Re: DART + Coastal North Railway Order 2024 - Northern Line between Dublin City Centre and Drogheda including the Howth Branch Dublin City Centre and Drogheda, located in counties Dublin, Meath and Louth

Re: Bord Pleanála Case reference: NA29N.320164

I wish to make a submission on CIÉ's Application for Railway Order DART+ Coastal North Railway Order 2024.

Railway Order – Works Layout Plan No. 10 Malahide Station and Surrounds https://www.dartplus.ie/S3mvc/media/DART-Coastal-North-Railway-Order/03.1%20RO%20Book%201/Railway-Work-Plans-Combined-(Set-1-of-3).pdf

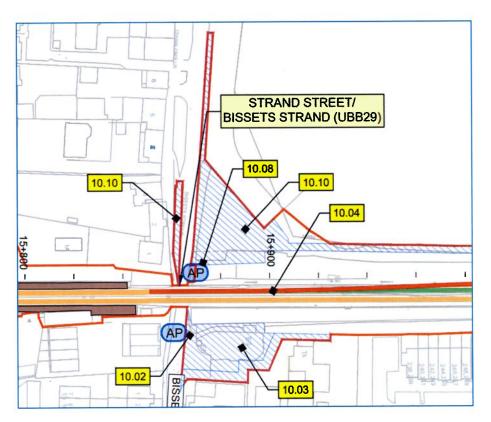
I live in the house numbered 3 shown on the section of the plan above i.e. in front of the narrow strip numbered 10.10. A photo of this section is shown.

This section of the road is used for parking by residents of the Strand, but is also used by rail commuters and shoppers as it is free parking and is in close proximity to the station and village. As residents of the Strand we do not have access to permit parking, despite many requests to Fingal County Council. We also do not have any access to permit parking in nearby areas. If access to this area is removed, even on a temporary basis, it will be

impossible for us to park anywhere nearby as the parking area on the sea side of the road is also included in Works No 10.10.

The photo shows the area which has been hatched with a yellow box to allow for the bin collection for 7 houses and no provision appears to have been made to facilitate this during the works in the documentation.

https://consult.fingal.ie/en/consultation/broadmeadow-way - Planning Drawing Layout 12_160_464.pdf

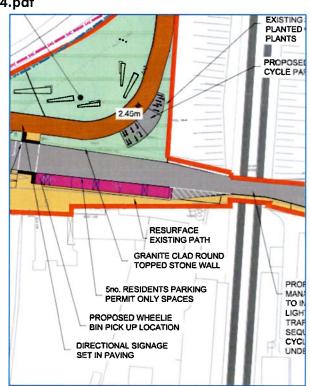
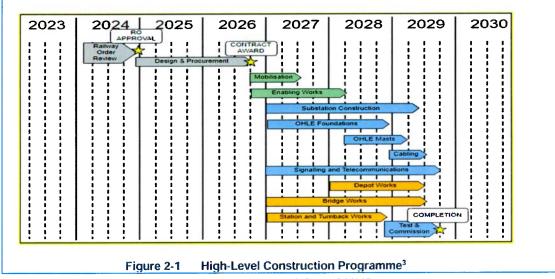
Currently the Broadmeadow Way is under construction. In Fingal County Council's (FCC) responses to submissions made to An Bord Pleanála (ABP) for the project they committed to providing 4 residents parking spaces in this area (note that 5 spaces were included in the design plans (see below).

If this area is used, even on a temporary basis, what provision is there for the residents parking which will be provided on completion of the walkway?

ACCESS POINT FOR PROPOSED WORKS COMPOUND Railway Order – Works Layout Plan No. 10 Malahide Station and Surrounds – https://www.dartplus.ie/S3mvc/media/DART-Coastal-North-Railway-Order/03.1%20RO%20Book%201/Railway-Work-Plans-Combined-(Set-1-of-3).pdf

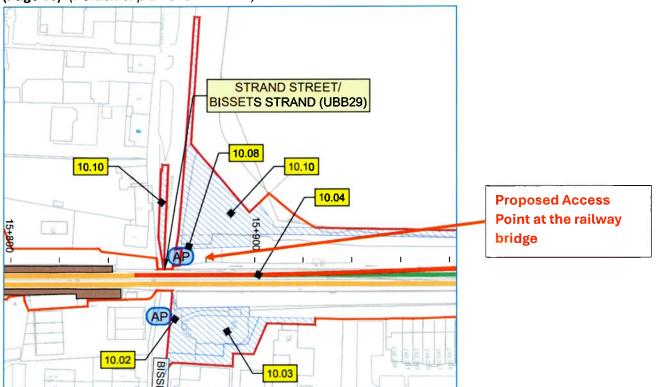
An access point is indicated on the plan (marked AP above). This access point location seems to be the reason for using the parking spaces as a temporary compound. This location is directly beside the protected mid 19th century railway bridge – the bridge can be seen in the photographs and it is listed in FCC Record of Protected Structures - https://www.fingal.ie/sites/default/files/2024-03/record-of-protected-structures-and-acas-2023-2029.pdf - *Item number 0423*

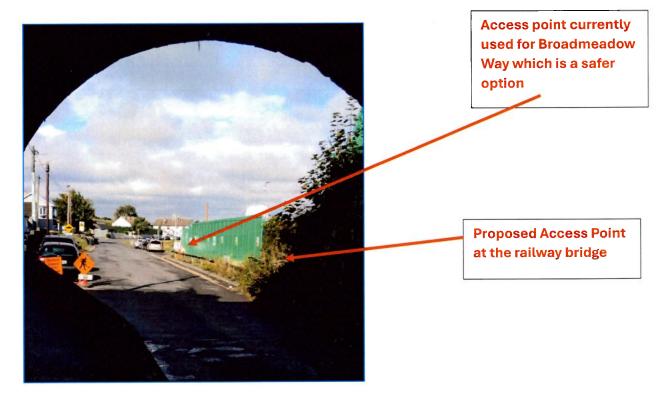
Currently the compound for the Broadmeadow Way works is located at the larger area marked 10.10 on the plan above. As this area is to be used as a temporary compound for Dart + Coastal North I feel that the current entrance should be used (see photos below). This has been the entrance for all the heavy work since 2009 (when the railway bridge collapsed). The construction of the access road for the bridge repairs in 2009 involved the delivery of large volumes of stone etc. and this access point was used then. Now during the construction of the Broadmeadow Walkway bridge delivery of various types of stone, very large precast concrete elements, delivery of large construction machinery (cranes etc.) use this entrance.

Reading the description of the works and the types of equipment to be used to complete the works it appears that the proposed access point is not sufficient for the safe access and egress of equipment etc. The photos below show the types of equipment currently on the site for the Broadmeadows Way works, and all equipment and materials have been delivered using the access point well away from the bridge, leaving the parking bay opposite available.
